Subject: FEBEG's position regarding the public consultation on a proposal for amendment to ELIA's LFC block operational agreement

Date: 16 June 2022

Figure 1: Evolution of ACE and SI Quality

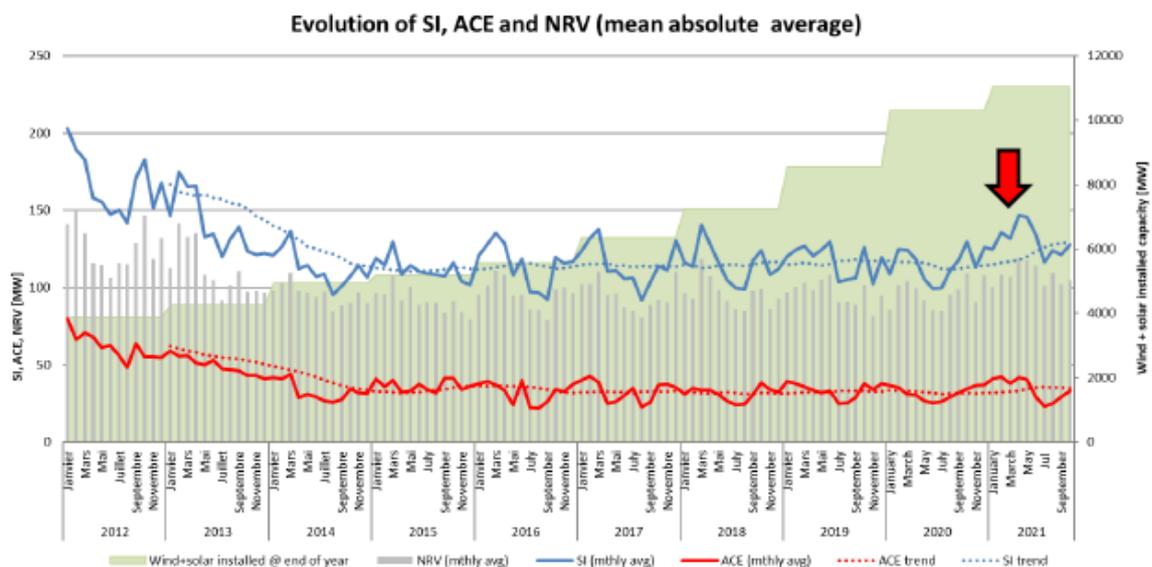
We would like to remind that in the current version of the LFCBOA, a ‘static’ probabilistic method to dimension the aFRR needs is used, based on a time series of two years of expected variations between quarter-hours of LFC block imbalances. The *aFRR reserve capacity needs* are determined by the capacity that can cover 79% of the historic 15’ LFC block imbalances variations. This 79% target is fixed since 2016 as, based on an empirical assessment, it was found to result in a sufficient FRCE-quality. The fact that the IGCC netting is not taken into account ex-ante (we like to underline that its availability cannot be guaranteed) makes, among others, that procuring only 79% of the absolute variations still yields a sufficient FRCE quality. **In other words, if IGCC netting would be taken into account, one cannot simply assume that 79% would still give a sufficiently robust outcome from grid security perspective.**

Figure 4: Benchmark of FRCE level 1 & 2

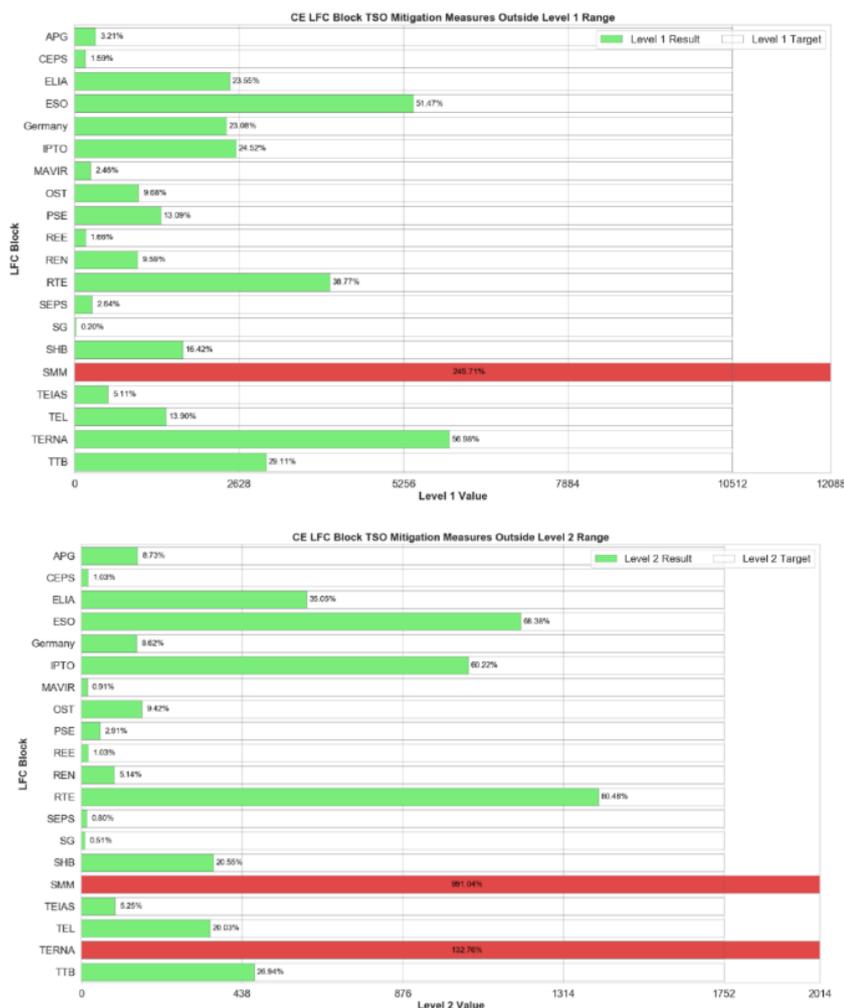
In fact in **ELIA’s 2020 study**, it was already demonstrated that Belgium has a more or less average (not bad, but also not “top of class”) performance in terms of the legal minimum criteria (FRCE level 1 & 2), and that ELIA procures little aFRR in comparison with its neighbouring countries. See infographics *Figure 4* (Benchmark of FRCE level) and *Figure 5* (Benchmark of aFRR procured volumes). It **concluded therefore to have little margin for aFRR means reductions as the available aFRR means procured are already relatively low** compared to other countries and FRCE-management of individual LFC blocks is important to maintain stable frequency in the European synchronous zone. Furthermore, SOGL art 128 clearly states that FRCE level 1 and 2 should not be exploited to reduce contracted reserves. See infographics *Figure 6*.

**Based on ELIA’s own study and benchmark check, FEBEG can only come to the conclusion that ELIA will be less capable maintaining the Belgian grid balanced and is entering unknown territory. This further strengthens our concerns with the proposed methodology changes and the lowering of aFRR means.**
